Three Questions from NRC.

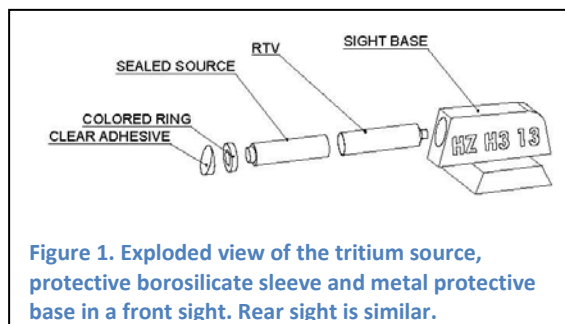
a. In Attachment J, “Dose Calculations,” Selection D, “Accident Scenarios Considered,” for Scenarios 1 and 2, you assume that 5 percent and 1 percent of devices, respectively, are destroyed in the conceived fire conditions. Please explain why these particular percentages were selected and why the probability of these scenarios is considered to be “low.” Furthermore, please explain why the probability of Scenarios 4 and 5 are considered to be “low,” and why the probabilities of Scenarios 3 and 6 are considered to be “negligible.”

Please explain why these particular percentages (5 percent and 1 percent of devices for Scenarios 1 and 2, respectively) were selected and why the probability of these scenarios is considered to be ‘low.’”

These devices consist of gaseous ^3H (tritium) sealed into a protective base (Fig. 1) that is constructed of borosilicate glass. Borosilicate glass is high-temperature resistant and is used for laboratory glassware (e.g., beakers and flasks) which is subjected to quite high temperatures. Borosilicate glass (sold under such trade names as Pyrex, Endural and Schott) is highly temperature resistant. The softening point of Pyrex is 820°C ($1,510^\circ\text{F}$). It is also used in implantable medical devices and devices used in space applications, where ruggedness and a very high degree of reliability are essential. Additionally, the glass cylinder containing the tritium source is well protected within a metal mounting bracket (Fig. 1, 2 and 3).

Borosilicate glass is known for having very low coefficients of thermal expansion, making it resistant to thermal shock, which reduces material stresses caused by temperature gradients. All of these attributes make borosilicate an excellent material for use in tritium gun sights.

During an internet search I was unable to find *any* mention of incidents or accidents involving tritium gun sights in manufacturing, in warehouse storage or in transport¹. While history provides no protection against future events, no significant incidents since these devices were first introduced in the mid-1980s must count for something.

Notwithstanding speculative scenarios in NUREG 1717 and possibly other documents, involving hundreds or a thousand of these sights, the fact of the matter is that we know of no such incidents occurring. Also, given the excellent design and robust construction of these sights, I believe that my breakage/destruction estimates in Scenarios 1 and 2 are realistic but conservative based on existing evidence.

Additionally, my judgment of low and negligible likelihood is also supported by the evidence we have, which indicates that the likelihood of destruction or breakage of large quantities of these devices in a single incident is extremely small.
